SWEETGREEN NJ147

Tuesday, June 14, 2022

10 Remarks Identified

RTU-1
Kitchen

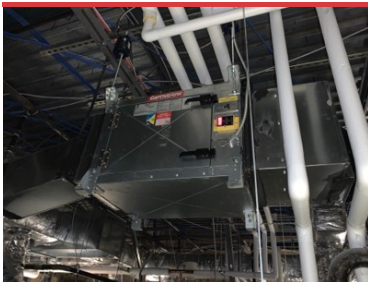
RTU1/2 NOTE

OCC was not wired so temporary jumper is installed.
Recommend connecting OCC to proper terminal on the thermostat

RTU1-2 FILTERS ARE HEAVILY LOADED

Need 4 per unit 20X25X2

8 Total

GX-1
Kitchen exhaust

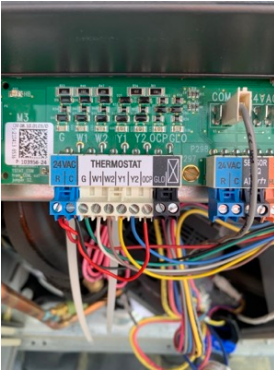
KITCHEN EXHAUST DISCHARGE
